# ADDENDUM NO. 2 EL EVADO ROAD AND OTHER ROADS WORK ORDER: H15071 AREA: Victorville

ROAD NO.: 318550 020; 292050 020; 302700 020

ADDENDUM NO. 2 El Evado and Other Roads March 31, 2021 Page 6 of 6

SHEET 9 OF 11

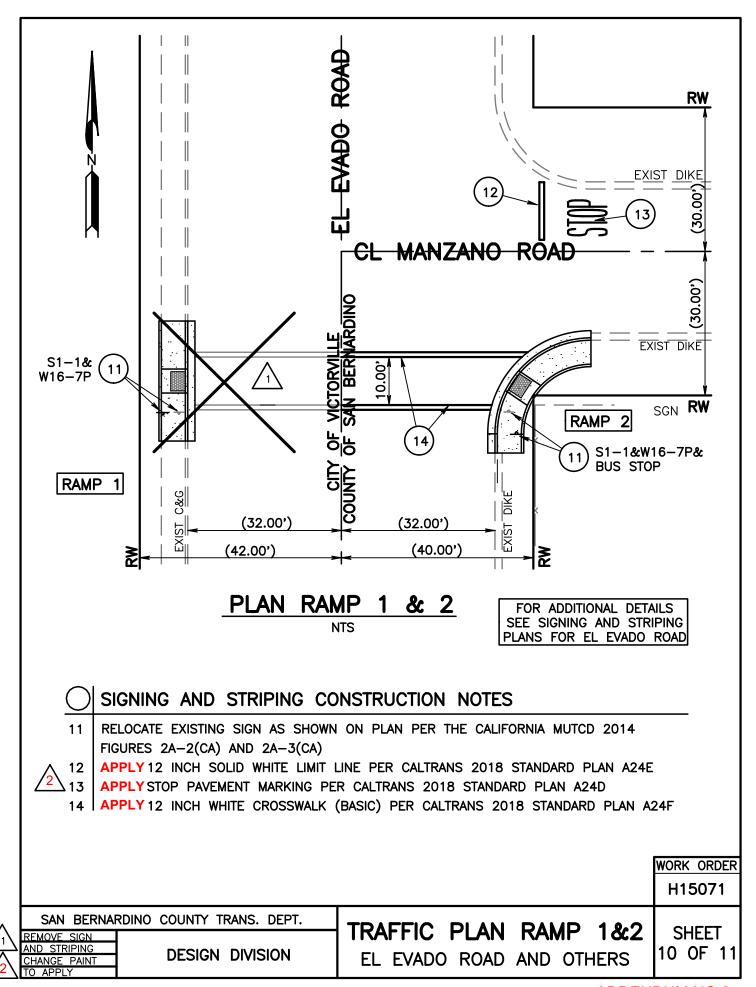
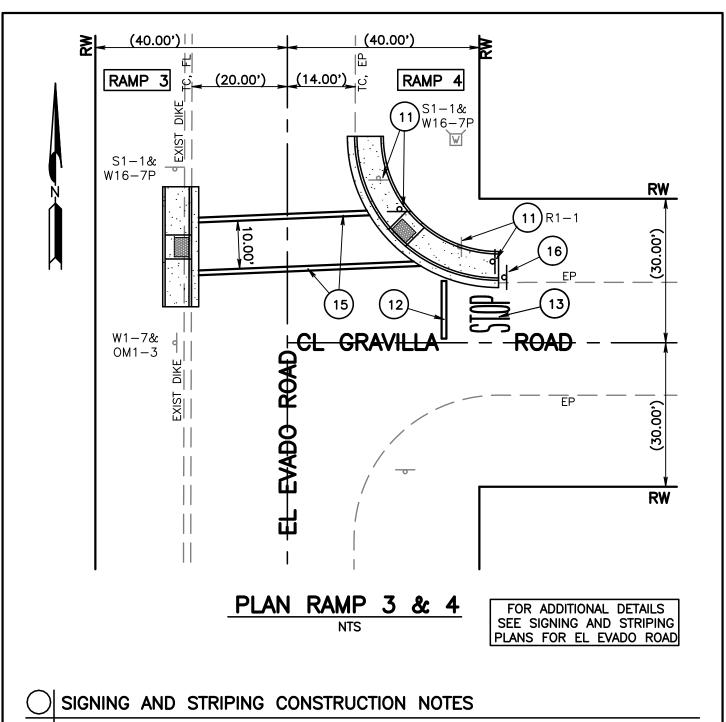
CHANGE RETRO REFLECTIVE TO THERMOPLASTIC AND PAINT TO APPLY

Delete and replace with Addendum No. 2, Sht. 9 of 11

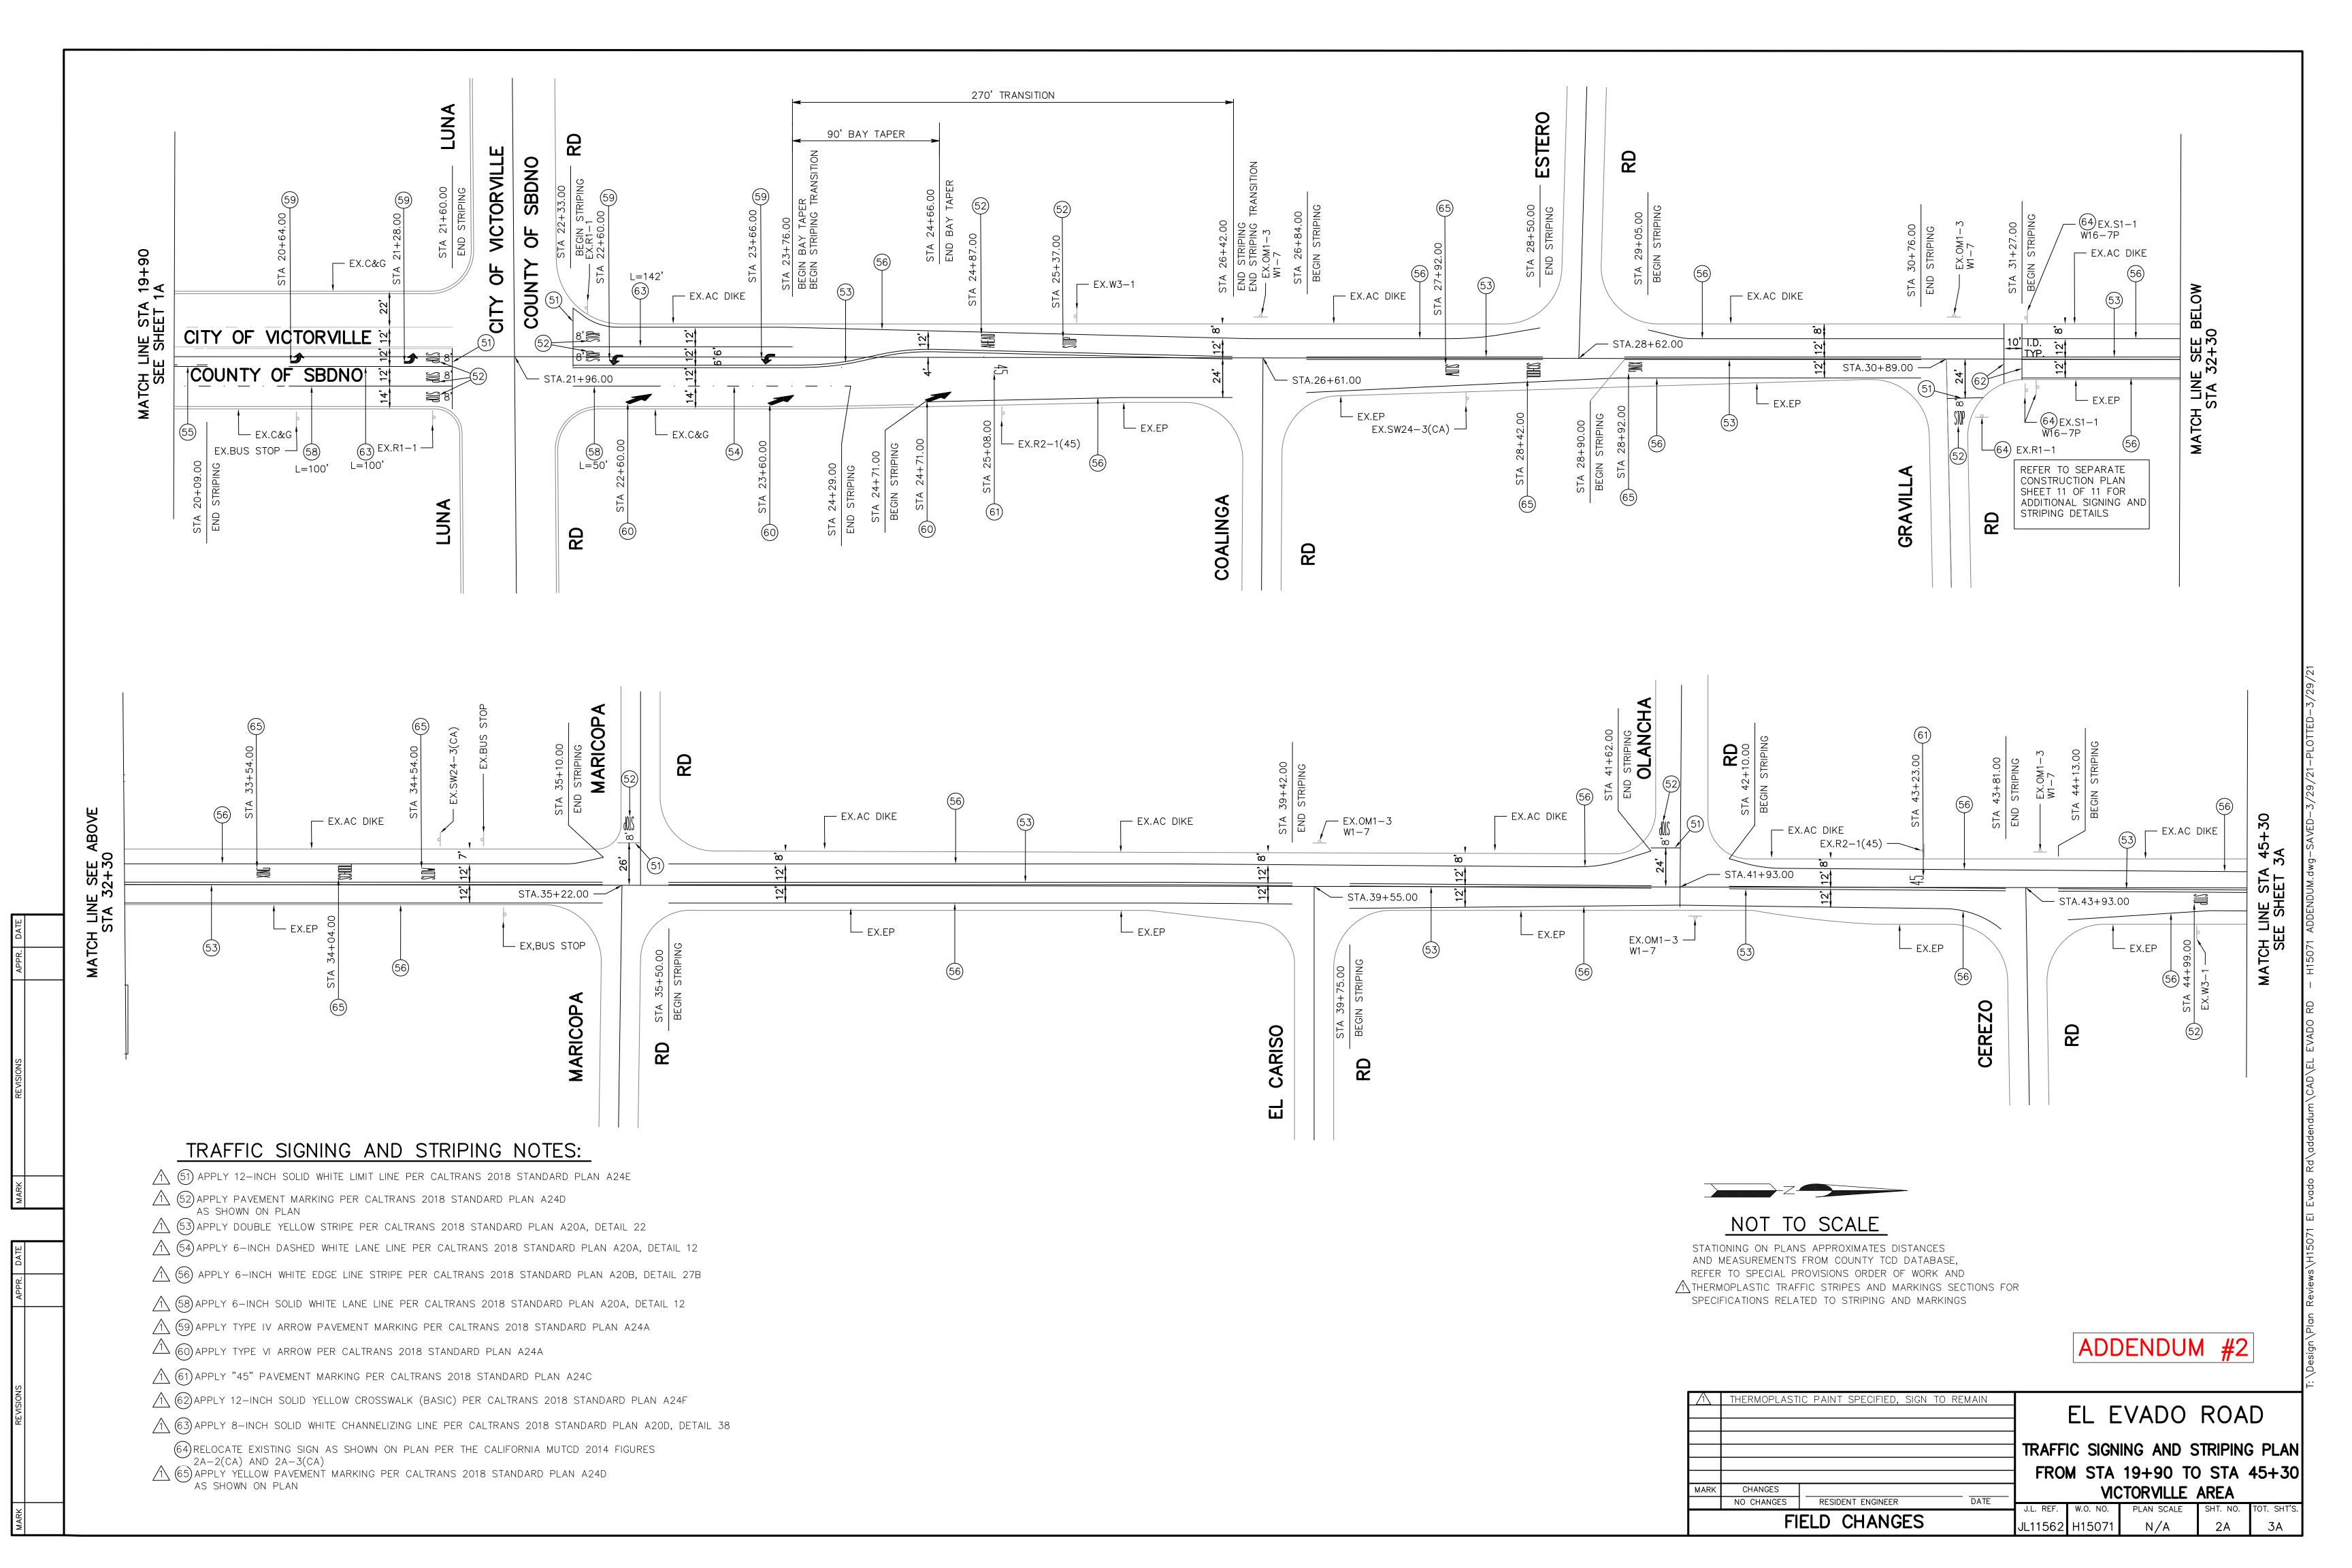
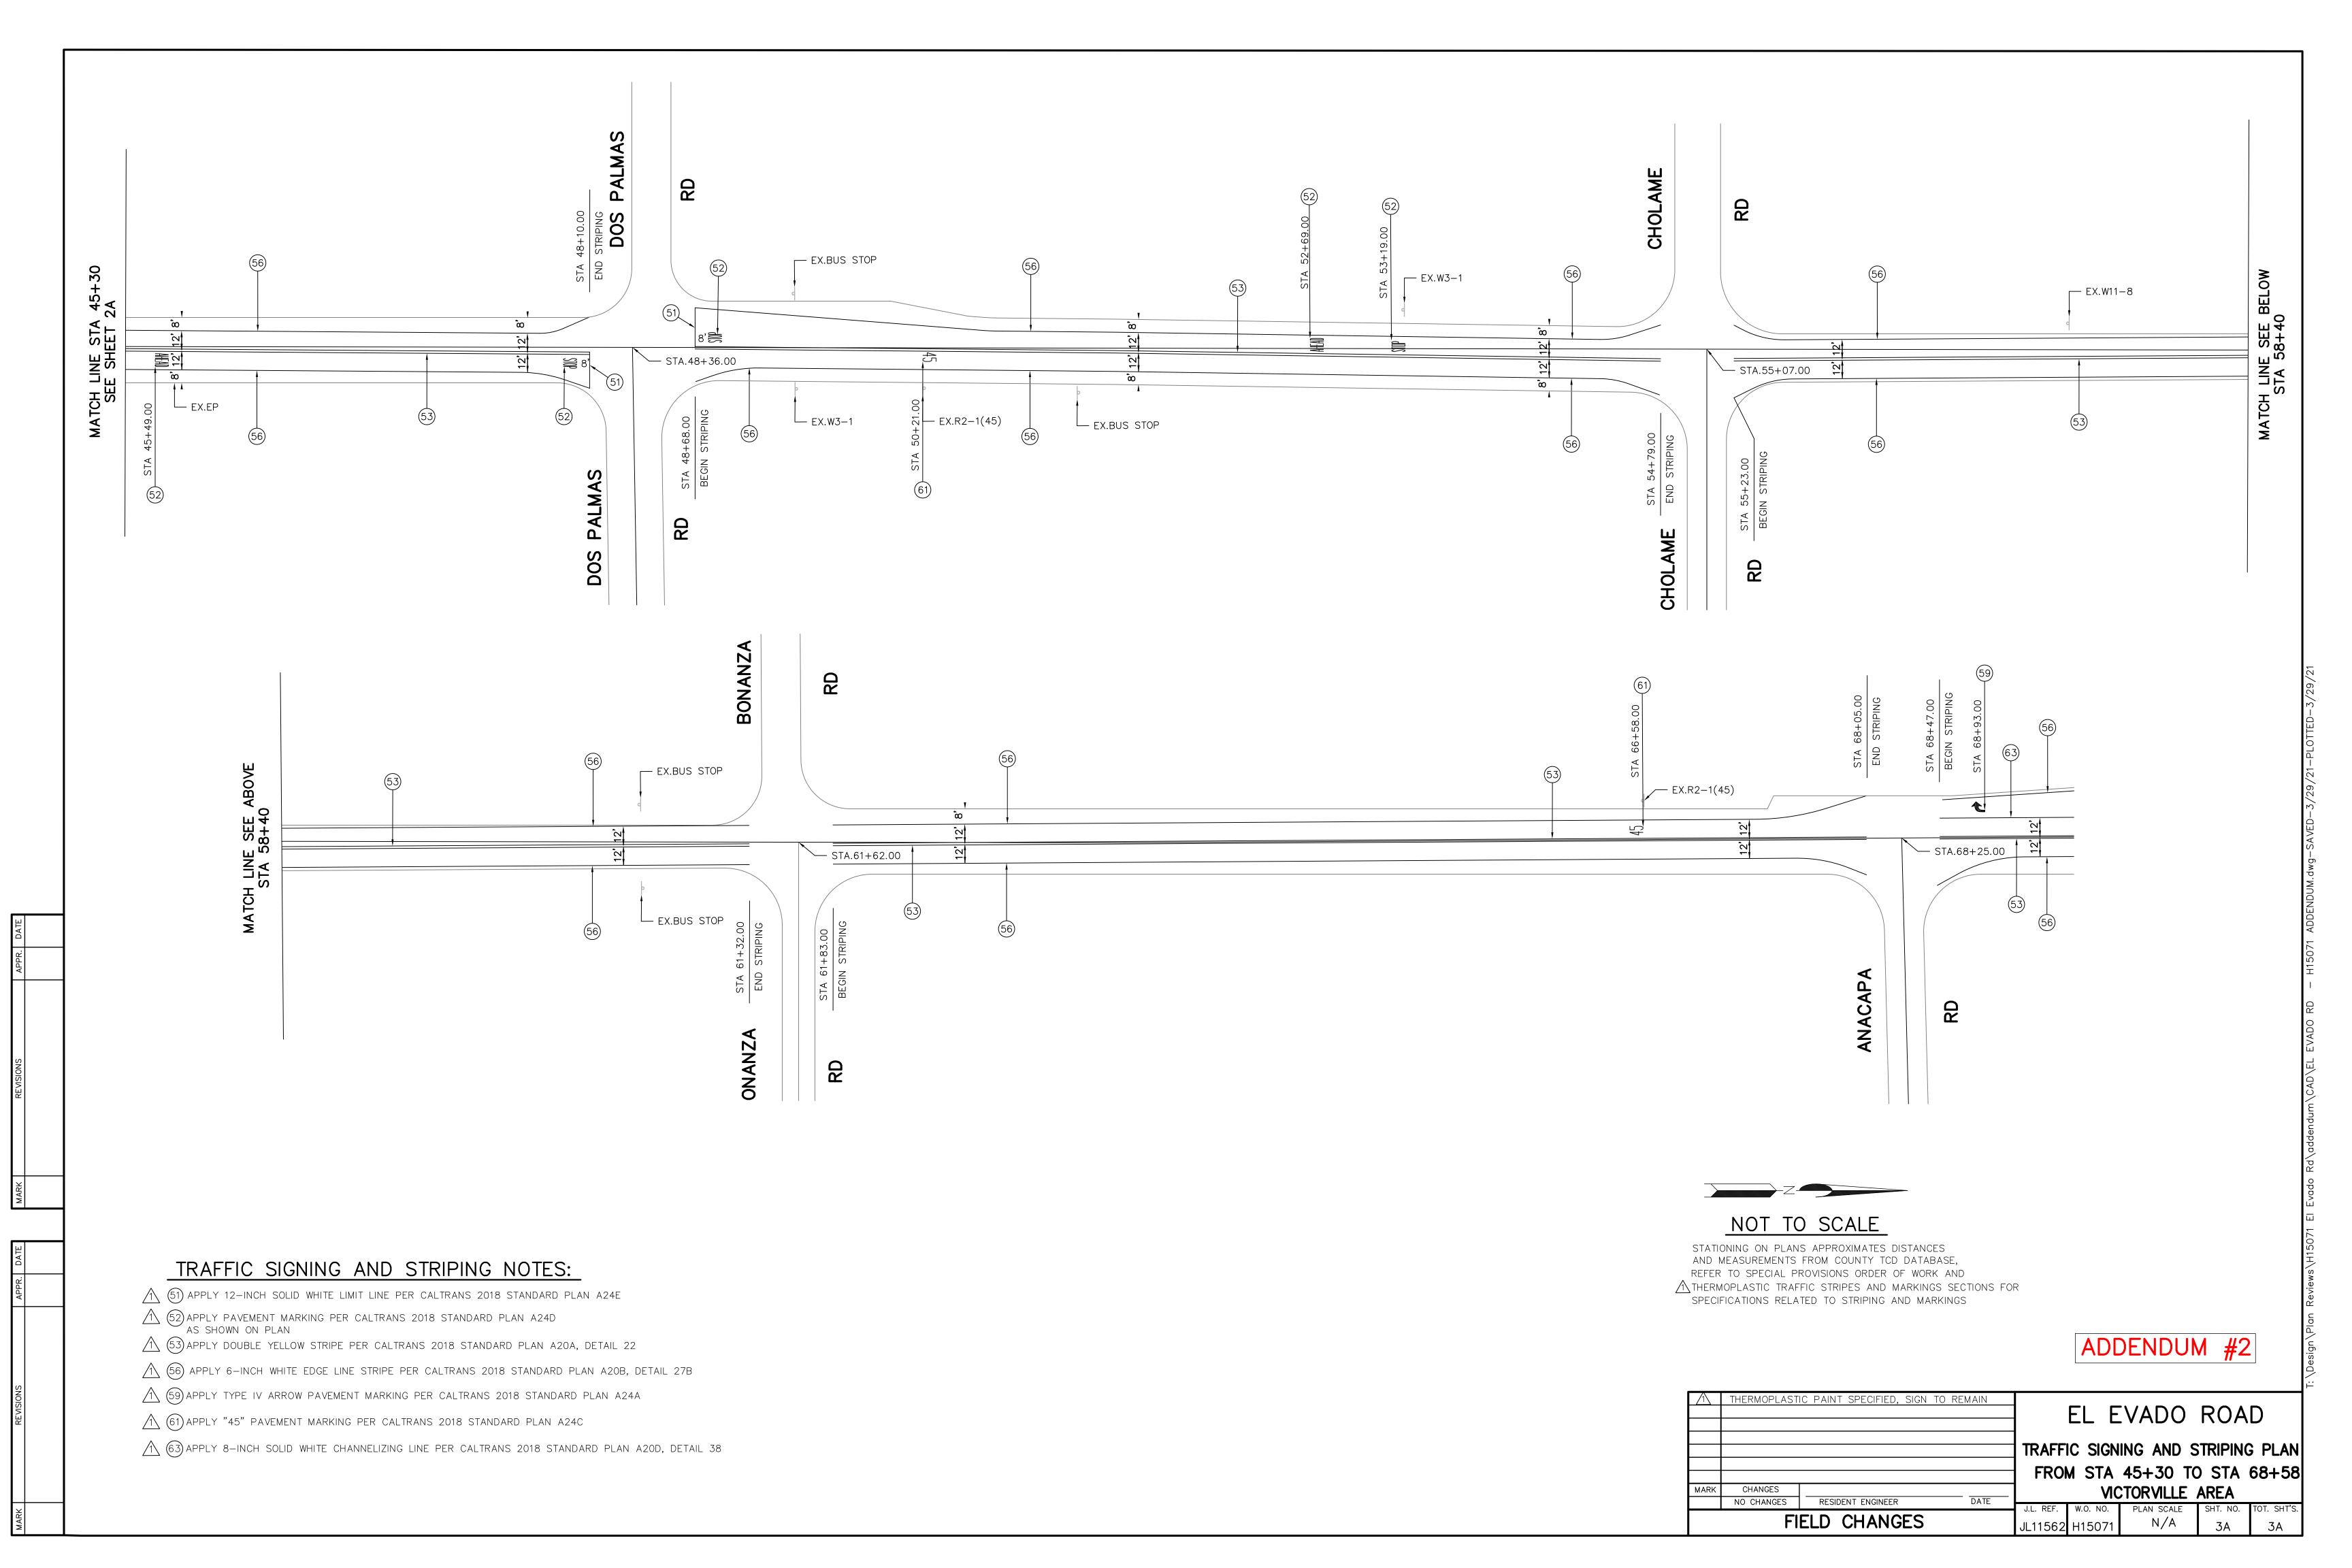
/1\	THERMOPLASTI	C PAINT SPECIFIED, SIGN	I TO REMAIN			VADO	PΩΛ	<u></u>
İ							.VADO	NOA	D
ļ					TRAFF	IC SIGN	ING AND S	TRIPINO	) PLA
ŀ					FRO	M STA	00+00 TO	STA	19+9
	MARK	CHANGES				VIC	CTORVILLE	AREA	
ļ		NO CHANGES	RESIDENT ENGINEER	DATE	J.L. REF.	W.O. NO.	PLAN SCALE	SHT. NO.	TOT. SHT
		FI	ELD CHANGES		JL11562	H15071	N/A	1A	3A

Delete Sht.'s 1, 2, and 3 of 3 and replace with Addendum No. 2, Sht.'s 1A, 2A, and 3A of 3A
